SUBJECT: JOSEPH M. FARLEY NUCLEAR PLANT, UNITS 1 AND 2 RE: REQUEST FOR
 ADDITIONAL INFORMATION — CATEGORY I COOLING WATER STORAGE
 POND DAM SAFETY AUDIT

OPERATION INSPECTION REPORT
for
THE NUCLEAR REGULATORY COMMISSION

Dam (name) Farley Category I Cooling Water Storage Pond Dam

Photograph 4

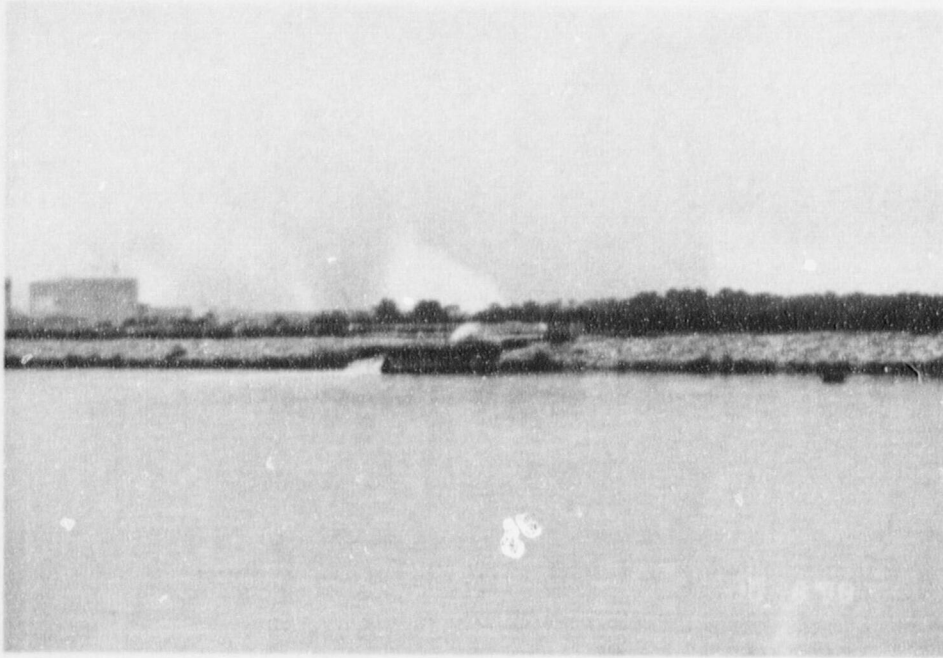
a. Storage Pond Dam. The dam was inspected by walking the crest and toe. Areas of interest were more closely examined on both the upstream and downstream slopes. The upstream slope (Photographs 1, 3, 4, and 7) was stabilized with stone (riprap) to protect the earth dam from erosion due to wave action. The stone appeared to be in good condition, with no indication of weathering. No abnormalities in the upstream slope such as sliding, sloughing, or subsidence were observed. A considerable amount of vegetative growth was observed in the riprap (Photographs 1 and 4). This vegetation should be treated to prohibit growth and removed as necessary.

- o A considerable amount of undesirable vegetation was found growing in the riprap on the upstream slope of the dam. The vegetation should be eliminated by either physical or chemical means. Environmentally

Photograph 5

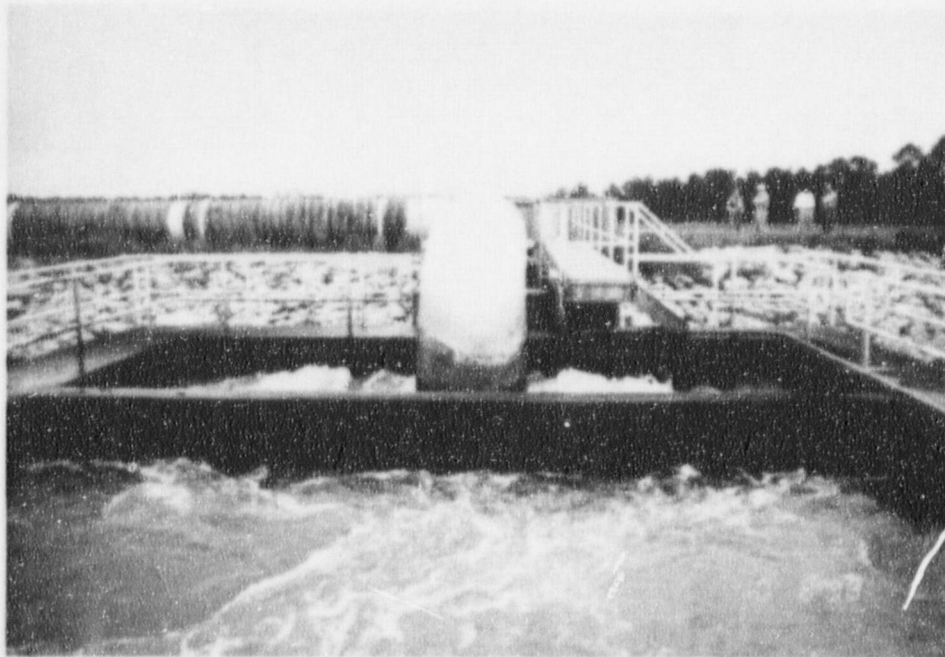
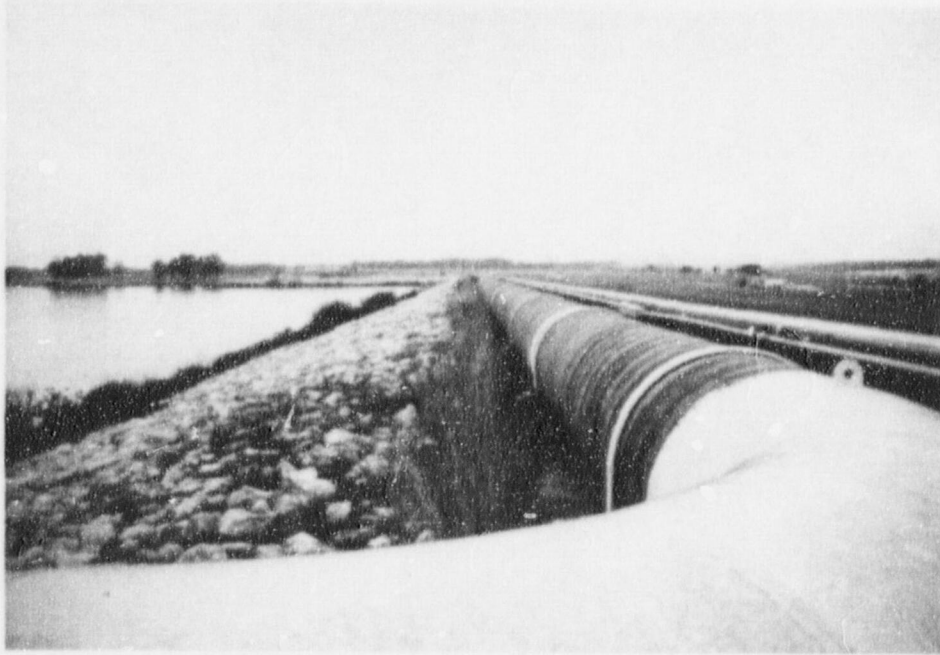
c. Other Structures. Other structures observed during the course of the inspection included the pond fill discharge (Photographs 5 and 6), the service water intake, the service water return, and the river intake (Photograph 14). No conditions were observed during the inspection that would indicate the need for remedial action, although some routine maintenance such as painting of the steel walkway and handrails at the pond fill discharge was needed.

Photograph 11

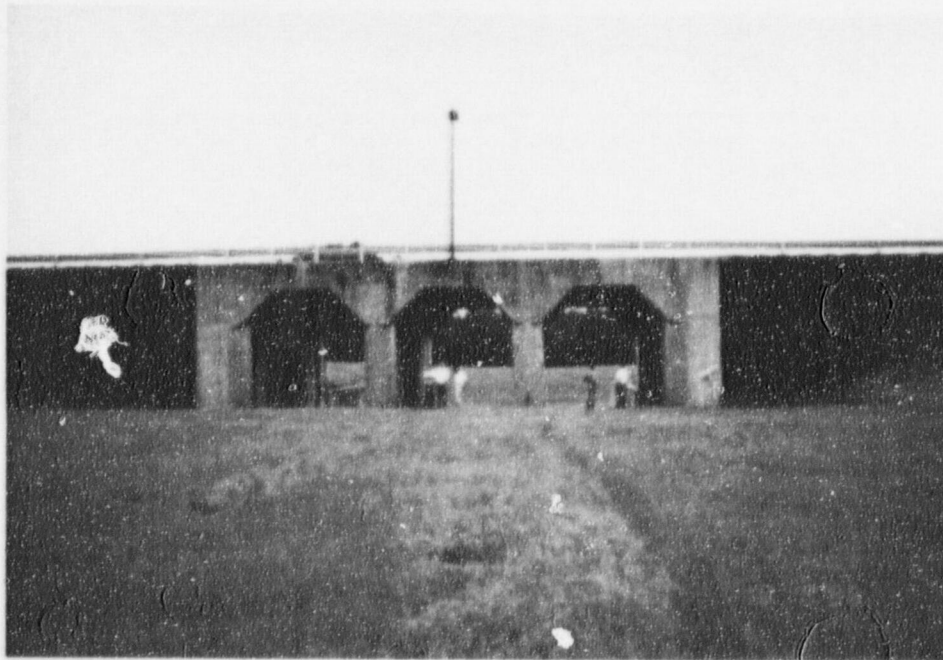
The downstream slope appeared to be in good condition (Photographs 2 and 11). The slope is protected by a well established grass cover. Some areas along the toe of the slope near the north end of the dam (Photograph 11) supported vegetation typical of that found in wet areas. The licensee's biennial inspection on June 10, 1998, was made after a period of dry weather

and found the area to be wet. This indicates the presence of seepage through the dam. The area should be kept under observation during routine inspections. Any change in the condition of the areas should be noted.

Photograph 12

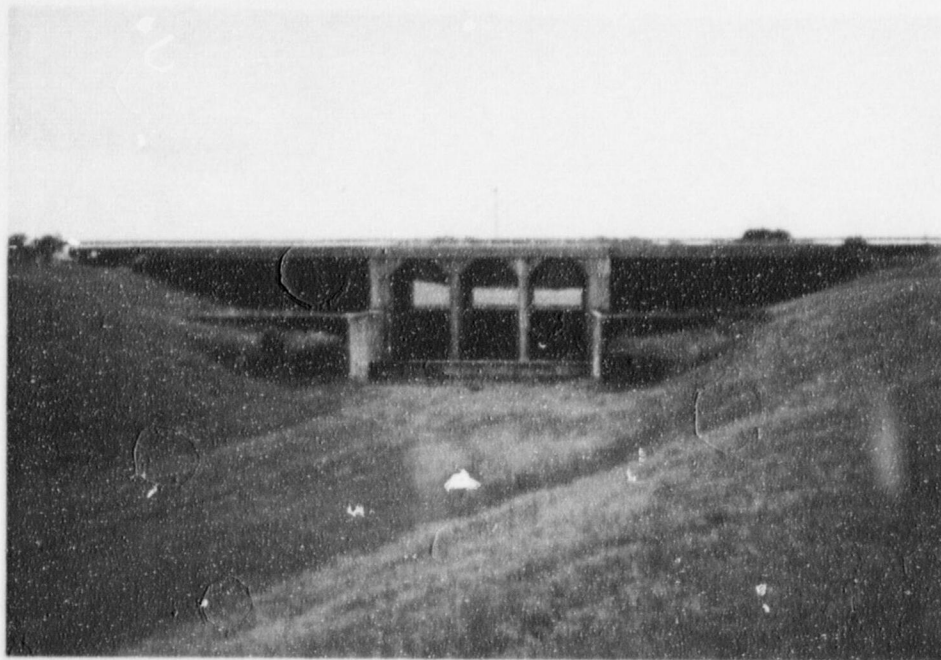
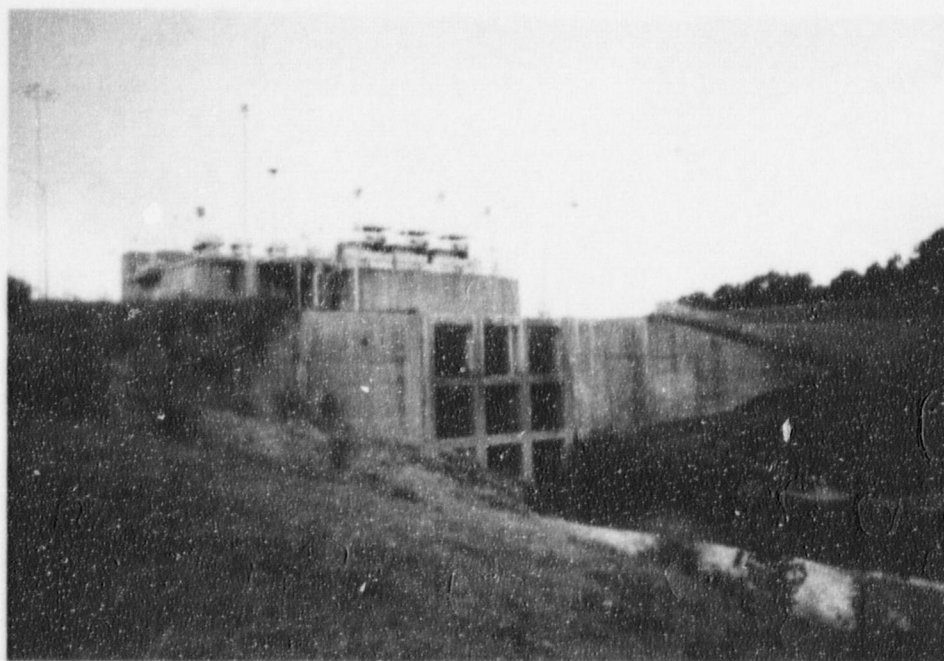
b. Spillway Structure. The spillway structure (Photographs 12 and 13) is a reinforced concrete, uncontrolled, three bay, drop type structure located northwest of the pond under the main entrance road to the Farley Nuclear Plant. The structure has relief wells equipped with flap valves in the floor to relieve hydrostatic pressure. The spillway channel connecting the pond to the drop structure is a large excavated ditch with grass lined,
